2008 AKA MANUAL

ADDENDUM No. 6

Issued: 5th February 2008

RE: MANUAL CHAPTER 36.20 – CORRECTION

IGNITION ROTOR

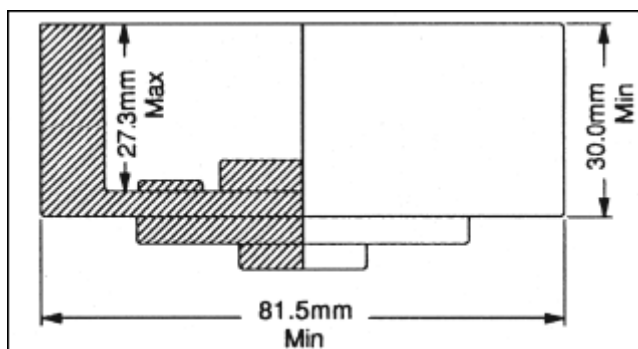
The following section Chapter 36 shows the correct wording of Chapter 36.20 – Addendum 6 reflects the wording below as a correction to the AKA Manual 2008.

- (i) Must be external rotor type and OEM supply.
- (ii) Both CDI and TCI ignition units as supplied by Yamaha are eligible.
- (iii) No modifications or internal repairs to the TCI unit are permissible.
- (iv) No CDI unit shall vary more than one (1) degrees between 5,000 rpm and 10,000 rpm.
- (v) It is permissible to repair/replace the connector for both CDI and TCI modules and mating wire.
- (vi) Maximum inside diameter measurement of the ignition rotor to be 62.00mm
